# SERVICE BULLETIN **Buell**<sup>®</sup>

B-018

## SAFETY RECALL CODE 0810 - FRONT ISOLATOR MOUNT SYSTEM

Figure 1. Front Isolator Mount

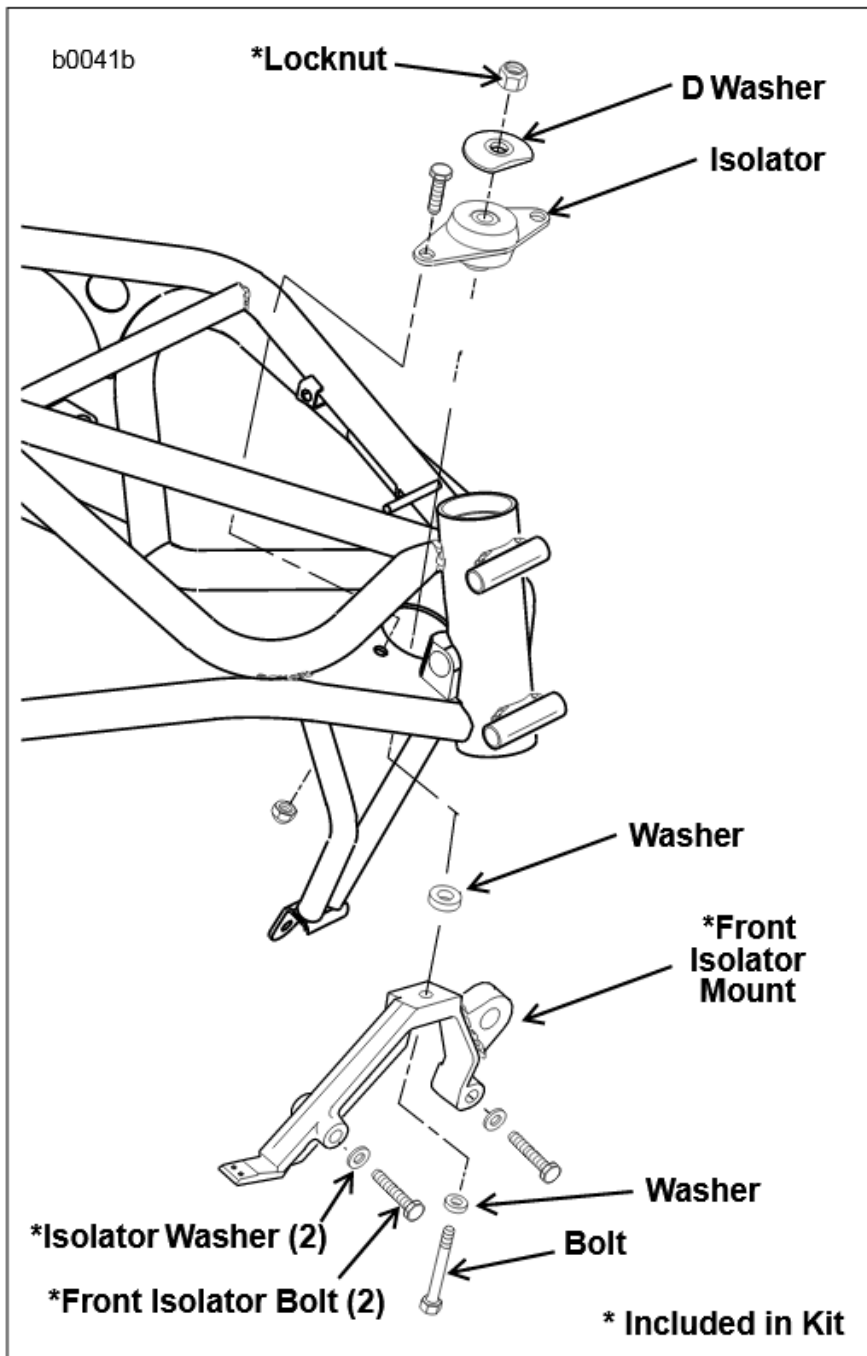
Buell Motorcycle Company has learned that certain 1997 and 1998 Buell motorcycles were built with an isolator mount system that could lose clamp load. Should this condition occur, it may allow the engine to move unexpectedly in the frame and cause an unintended distraction to the operator, which could result in an accident. Accordingly, Buell Motorcycle Company is conducting a voluntary recall campaign to formally recall all potentially affected motorcycles.

This condition will be remedied by replacing the front isolator mount system on all potentially affected vehicles.

8. Remove and discard two bolts and washers from left and right side of front isolator mount.
9. Remove front isolator mount from left side of motorcycle.

10. Clean residual loctite from threads in engine with a suitable nonflammable solvent and dry with compressed air.
11. Apply LOCTITE THREADLOCKER 271 (red) to threads of **new** front isolator mount bolts.
12. Apply a thin film of clean HD 20W50 engine oil to both sides of **new** thick washers and to bottom of bolt heads. Exercise caution to avoid mixing oil on washers with loctite on bolts.
13. Position **new** front isolator mount and secure with two **new** front bolts with **new** thick washers. Tighten bolts to 60 ft-lbs (81 Nm) initially and then loosen each bolt one full turn. Tighten bolts again to 60 ft-lbs (81 Nm).

14. Position washer between front isolator mount and isolator. Install bolt, washer, D washer and **new** locknut.
15. Making sure flat on D washer stays oriented to front of bike, tighten bolt to 100 ft-lbs (135.6 Nm).
16. Apply LOCTITE THREADLOCKER 243 (blue) to threads of airbox screws. Install airbox screws to airbox and front isolator mount. Install locknuts to screws.
17. Install air cleaner filter box and cover.
18. Connect negative battery cable.
19. Install fuel tank and seat.
